County of Fairfax, Virginia

Re: Interpretation for RZ/FDP 2002-HM-043, Arrowbrooke Centre, Tax Map 16-3 ((1)) 39A4: Site Modifications

ADMINISTRATIVE INTERPRETATION GRAPHIC

LANDSCAPING AS REPRESENTED ON
APPROVED CONCEPTUAL/FINAL DEVELOPMENT PLAN

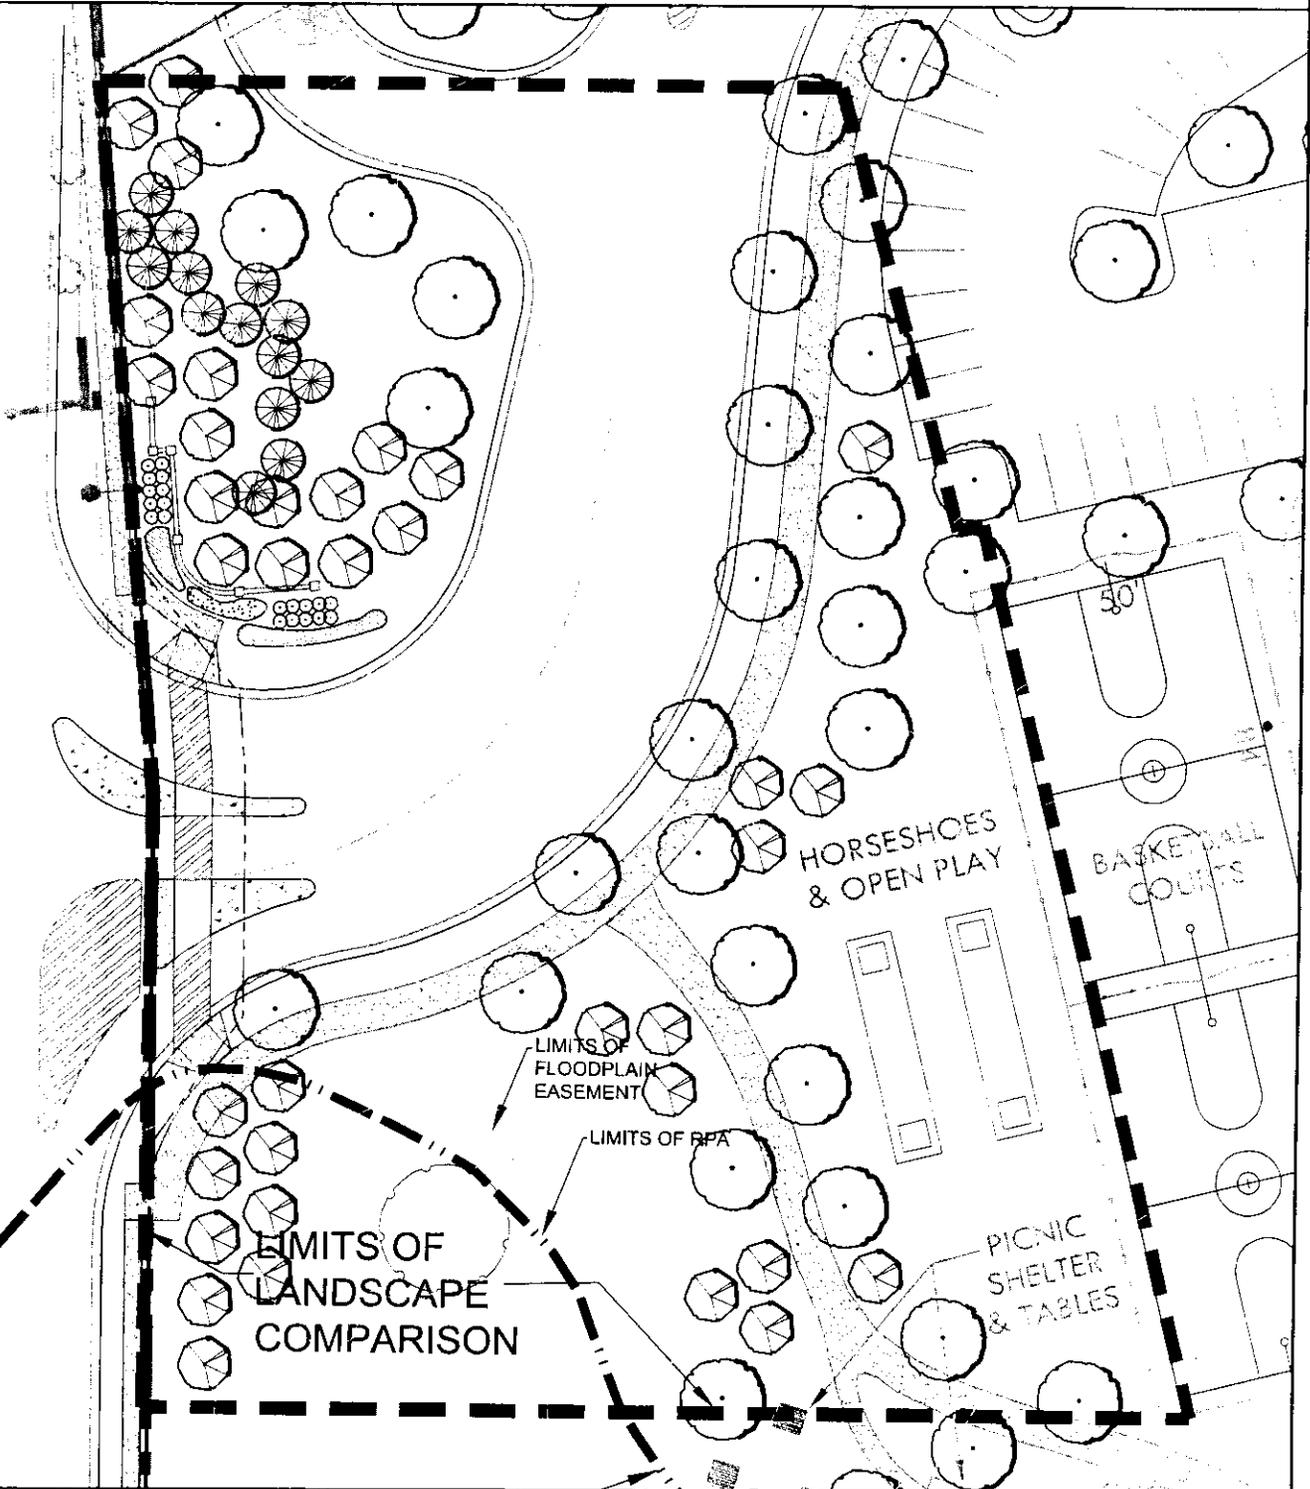
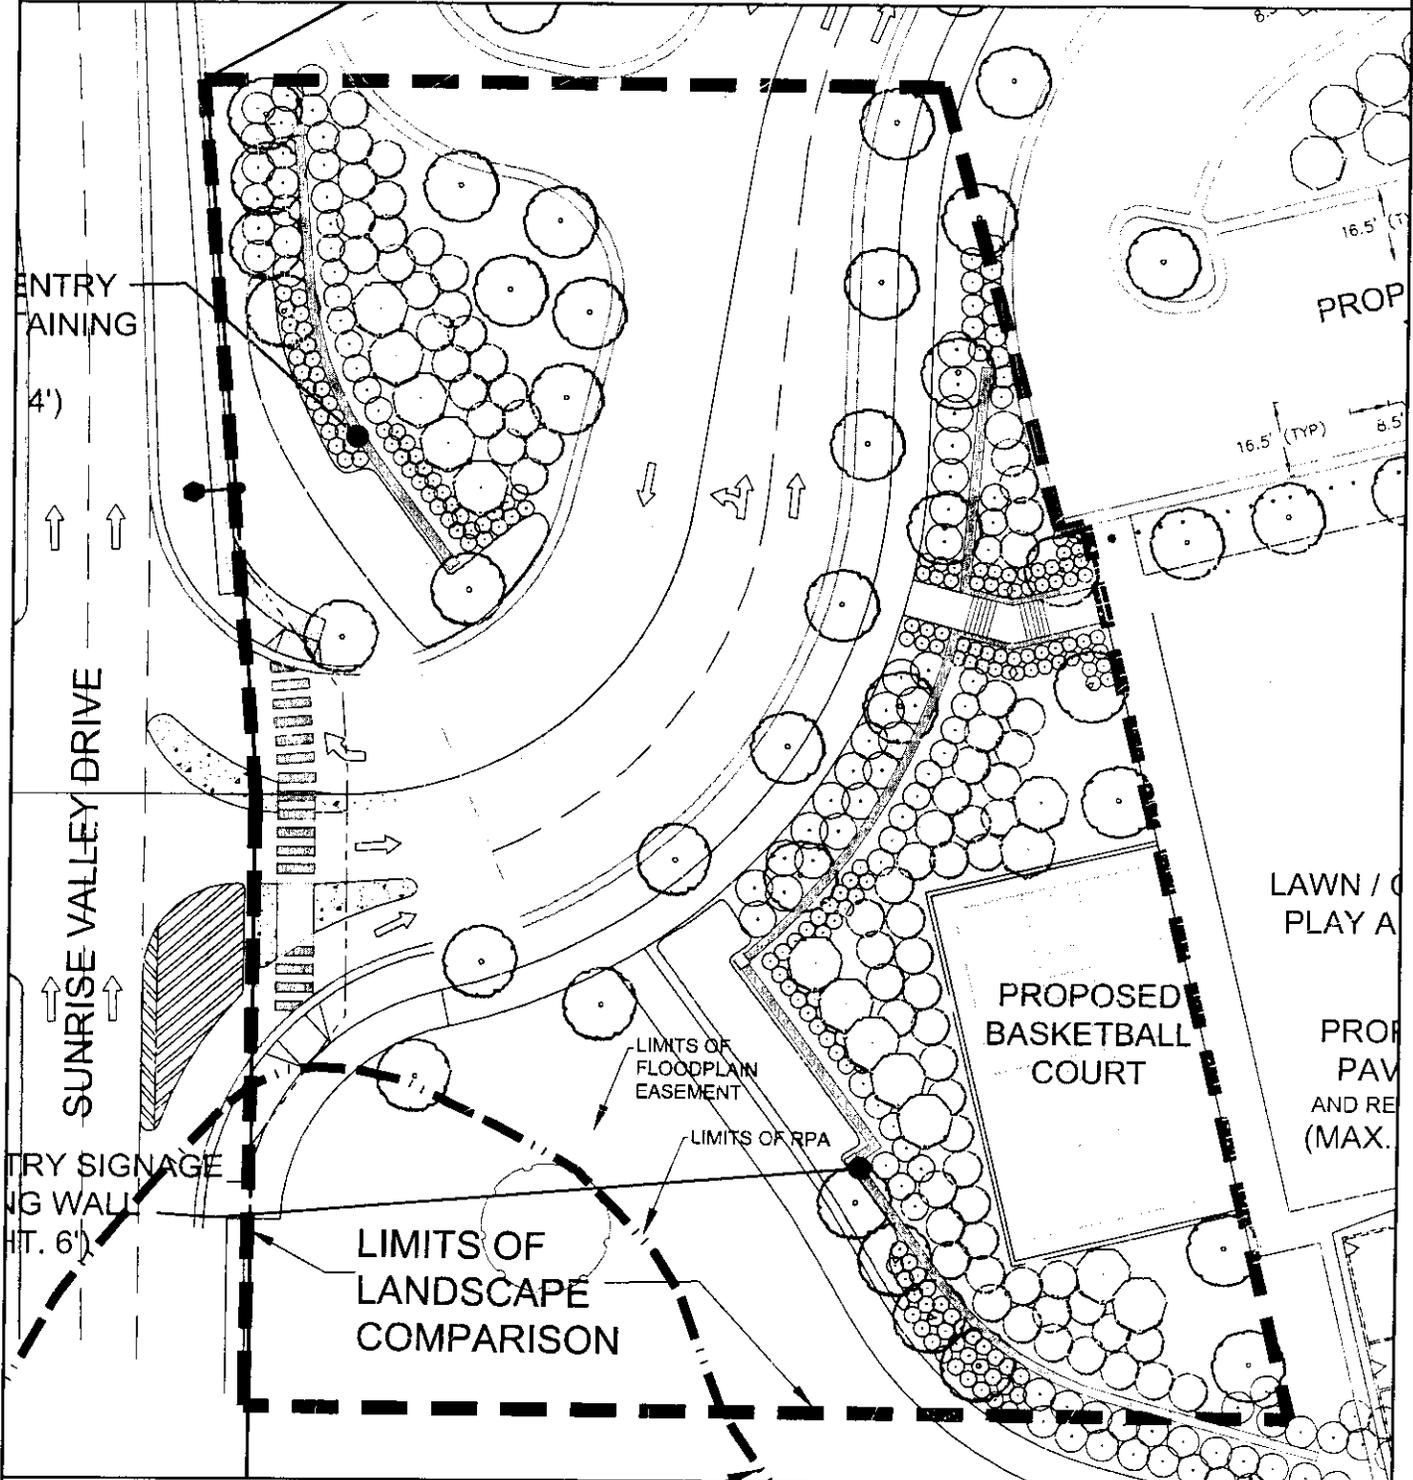
According to Exhibits 2A and 2B, the tree cover proposed is 13,825 square feet versus 9,775 square feet that was provided on the CDP/FDP. The difference results from an increase from 25 to 34 in the number of large deciduous trees, a decrease from 35 to 14 in ornamental trees, and an increase from 14 to 75 in evergreen trees. There is also a proposed increase from 20 to 294 in ornamental shrubs for which no tree cover can be claimed. Therefore, there is an increase in proposed tree cover with a significant increase in the number of evergreen trees, which is required for screening purposes.

- Exhibit 2A dated May 12, 2008 and Exhibit 2B dated July 7, 2008, provides a comparison of the landscaping shown on the approved CDP/FDP and as requested with this interpretation. Exhibit 2B is simply an enlargement of a portion of the interpretation graphic with tree cover calculations. The proposed modification provides 13,825 square feet of the cover compared to 9,775 square feet with the approved CDP/FDP.

As such, it is my determination that the proposed retaining walls and modifications to the landscaping at the Sunrise Valley Drive entrance to the site discussed above would be in substantial conformance with the proffers, the CDP/FDP, and the development conditions, subject to Urban Forest Management (UFM) approval of the revised landscape plan.

ADMINISTRATIVE INTERPETATION REQUEST
RESTORATION OF UTILITY CLEARINGDATE: 05.12.08
NOT TO SCALERESTORATION OF UTILITY CLEARING
CONCEPTUAL SECTION

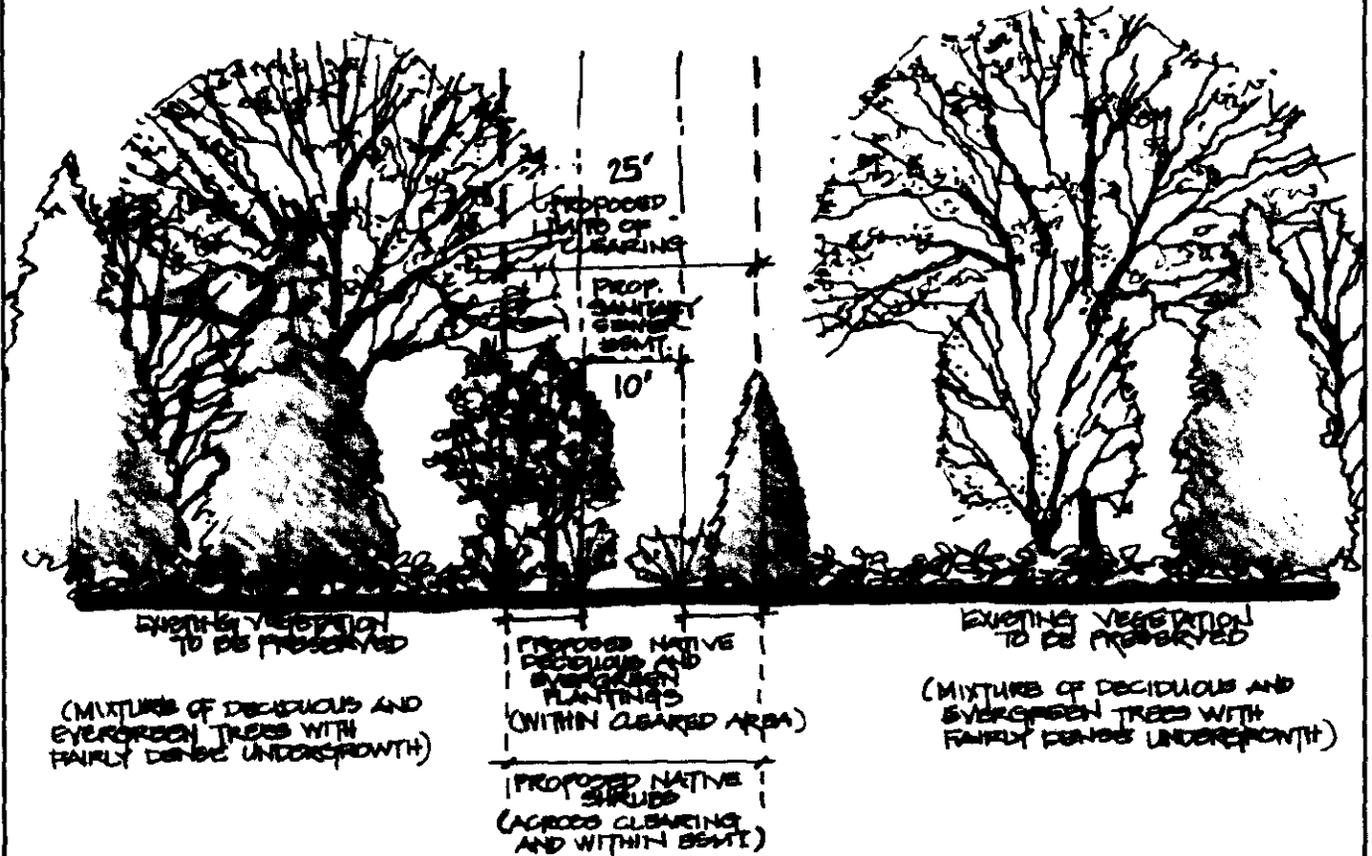
The tenth question (I) is whether the proposed re-alignment of a sanitary sewer line in the southeastern portion of the park area would be in substantial conformance with the proffers, the CDP/FDP, and the development conditions. You state that the proposed revision is the result of final engineering and the location of the tie-in to the existing trunk sewer. The approved CDP/FDP showed the proposed sanitary sewer in the southwest area of the site cutting through a narrow strip of trees to be preserved. You are now proposing to construct the sanitary sewer line further toward the east also through a larger area of existing trees to be preserved. Proffer 18C states that *"If as a result of final engineering, the areas designated as tree save areas on the CDP/FDP are modified or cannot be preserved, equivalent tree save areas or equivalent landscaped areas shall be substituted on the Property, as determined by Urban Forest Management"*. According to Exhibit 3A, the amount of clearing through a tree preservation area shown on the CDP/FDP was 2,500 square feet. You are proposing to reforest 2,650 square feet both within and outside the easement. Exhibit 3B shows the 25-foot wide reforestation area that consists of native deciduous and evergreen trees within the cleared area and proposed native shrubs across the cleared area and within the easement. Exhibit 3A also shows the proposed addition of supplemental landscaping between the easement and Sunrise Valley Drive to screen the easement.

- Plant selections are provided as a guideline for the restoration of the area cleared through the existing stand of trees as required for the proposed sanitary sewer connection.
- Native shrub plantings to be provided within the sanitary sewer easement and adjacent cleared area.
- Native deciduous and evergreen trees to be provided within the cleared area but outside of the sanitary sewer easement.
- Plant material to be provided at irregular spacing across the area to blend with the existing vegetation but provide a visual break along the clearing line.
- Native plant material to be selected to blend with the existing vegetation as well as to enhance survivability. Landscape material recommendations based on listing of "Native Plants for Conservation, Restoration and Landscaping" as outlined by the Virginia Department of Conservation and Recreation's Natural Heritage Program.

It is my determination that the proposed re-alignment of the sanitary sewer line with reforestation and supplemental landscaping discussed above is in substantial conformance with the proffers, the CDP/FDP, and the development conditions, subject to Urban Forest Management (UFM) approval.
